### **REMARKS**

**Amendments to the Drawings:**

FIG. 1

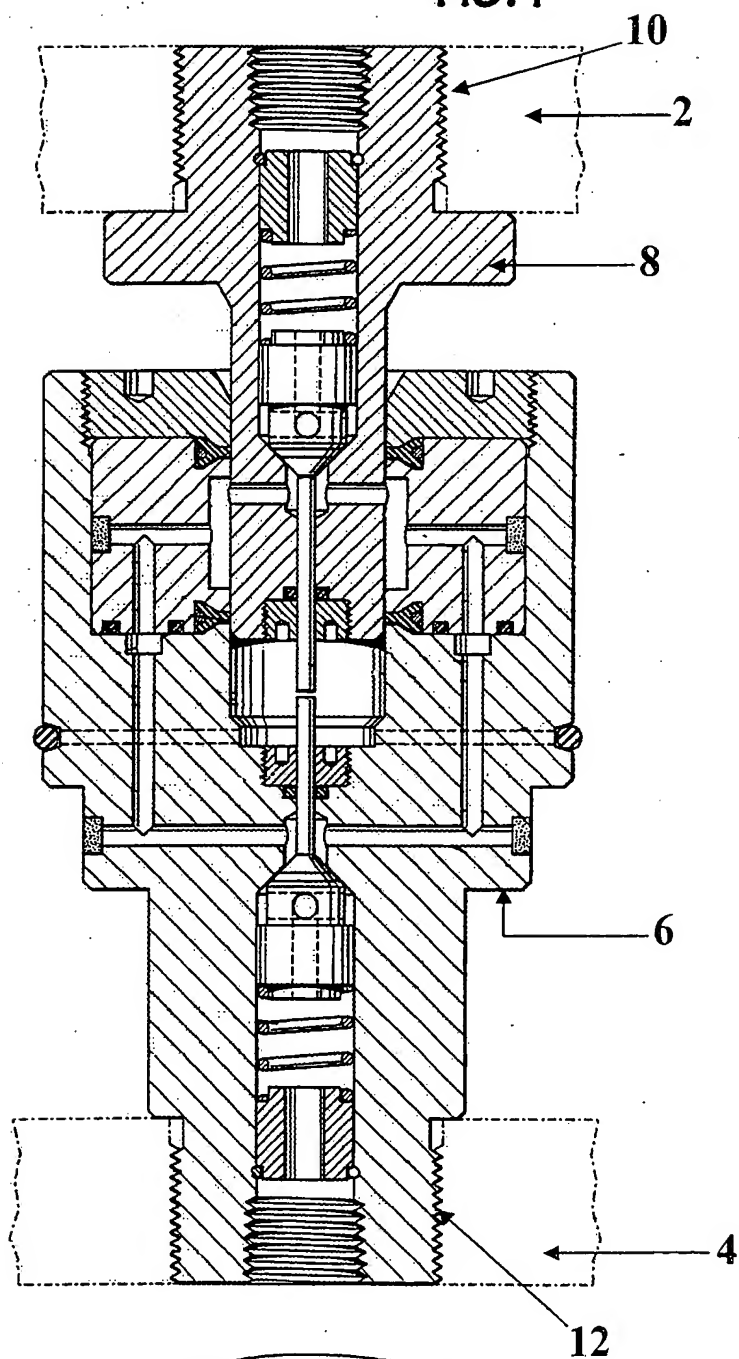
Figure 1 has been amended per the requirement of the Office Action to designate the hydraulic coupling illustrated therein as “Prior Art.”

The attached sheet of drawings includes changes to Fig. 1. This sheet, which includes Fig. 1, replaces the original sheet including Fig. 1. In Figure 1, the annotation "Prior Art" has been added.

Prior Art

added
